#### **Minneapolis Planning Department**

#### **MEMORANDUM**

**RE:** Appeal: Great Brakes at 3326 University Avenue

**Appeal:** Site Plan Review (BZZ-369). Great Brakes, 3326 University Avenue (Ward 2):

EXISTING BUILDING PHOTOGRAPH WITH NEW & FUTURE BUILDING SIGN LOCATIONS

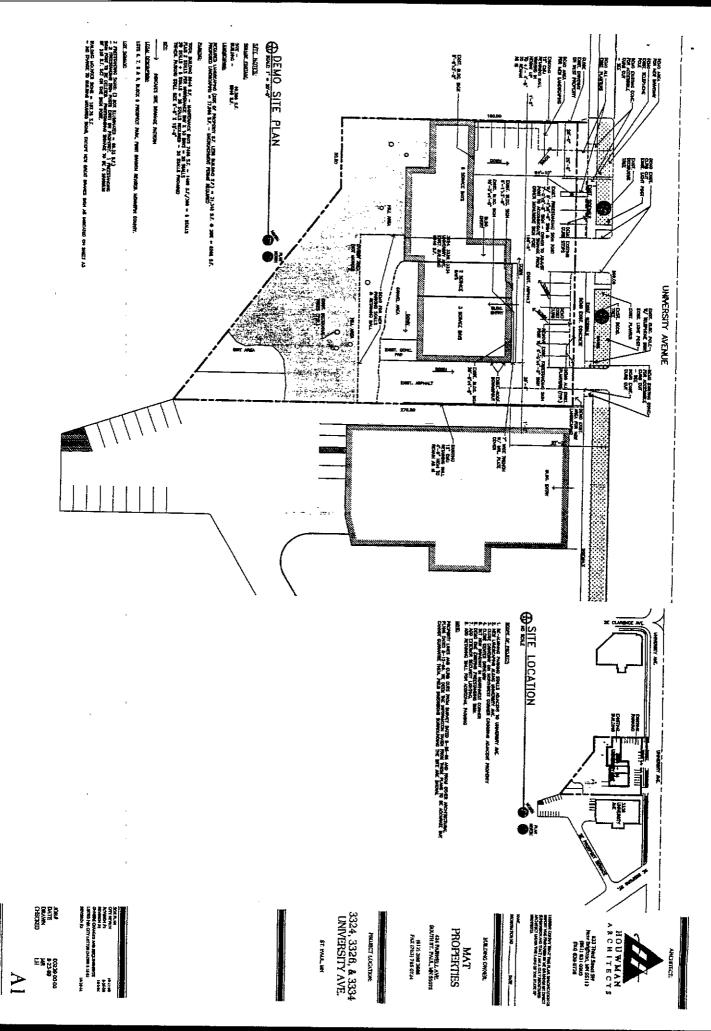
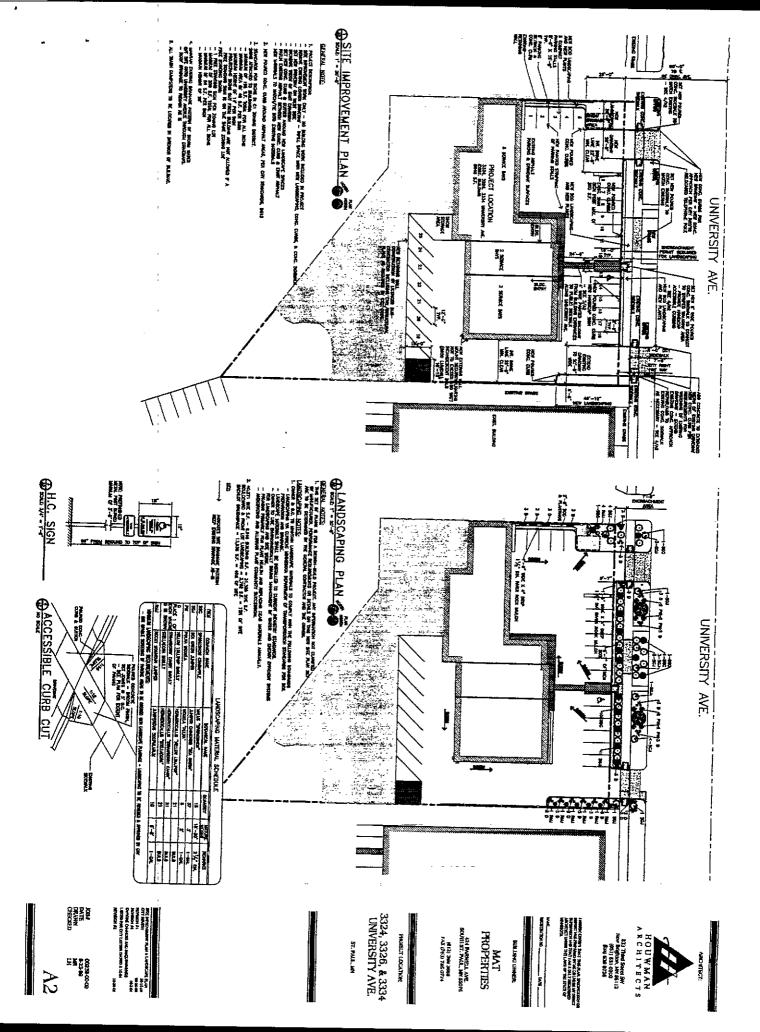
The Prospect Park East River Road Improvement Association, Inc. appeals the approval of this site plan. Great Brakes site plan does not meet the percentage of landscaping required or the number of trees and shrubs required. This meager landscaping will not screen the parking area from University Avenue. The plan does not address the incompatible facades of the two businesses or the negative impact of this site at the gateway to Minneapolis from St. Paul.

- The proposed landscaping is 12%. The Zoning Code requires 20% landscaping. It is not even close to what is required. There is a very steep hill with some trees behind the building. Although there are some trees clinging to this hill, it is not a "landscaped area." The applicant proposes to build a retaining wall in this area. This may destroy many of the trees.
- The Zoning Code requires 31 trees and 156 shrubs. The Planning Commission approved the site plan with only 15 trees, one half of the requirement, and 55 shrubs, approximately one third of the requirement. 63 daylilies were included in the applicant's 118 count of shrubs.

Great Brakes is painted brown and beige with new yellow and black signs. This sign was installed without a permit and before the 10 day appeal period had expired. The other auto related use is painted white with a deep blue and green stripe. Ignoring the incompatible facades and signage does not mitigate these the negative impacts on the nearby residential area. After years of being subjected to the visual pollution of this site we finally have an opportunity to improve it. We have not had this opportunity before. Your support of compliance with the landscape and screening provisions of the Zoning Code or alternate compliance will be greatly appreciated by all of us who have endured the visual pollution of this site for years.

The building façade, along University Avenue, does not contain windows at eye level and therefore does not maximize visibility nor meet the requirement to have windows on at least 30% of the first floor façade that faces a public street. The exterior materials and appearance of the entire building are not compatible on each façade. Each automobile repair use business has painted their portion of the building differently. The existing structure has two office entrances. Please see attached photos of the facade. The separate business's facades are compatible.

The applicant has proposed one freestanding sign of 200 square feet. The existing wall signs total 187.75 square feet. According to Table 543-2 Specific Standards for Signs in the OR2, OR3 and Commercial Districts, a lot zoned C1 is limited to one square foot of signage per one foot of primary building wall if a freestanding is on the same zoning lot. This site does have a freestanding sign and therefore wall signs shall be limited to 195 square feet. The existing building wall signs are within the allowable square feet. According to Table 543-2, only one freestanding sign is permitted per zoning lot. The freestanding sign is limited to one foot of signage per one foot of frontage. Therefore, the freestanding sign is limited to 200 square feet.

- A snow removal plan shall be required if the area dedicated for snow removal at the rear of the site is inadequate.
- The colors of the new Great Brakes building wall sign shall be black lettering on a white face.

- The applicant shall provide the neighborhood group with a letter of intent to paint the building within three to five years. The new paint for each building shall be harmonious in color yet allows for distinction between each use.
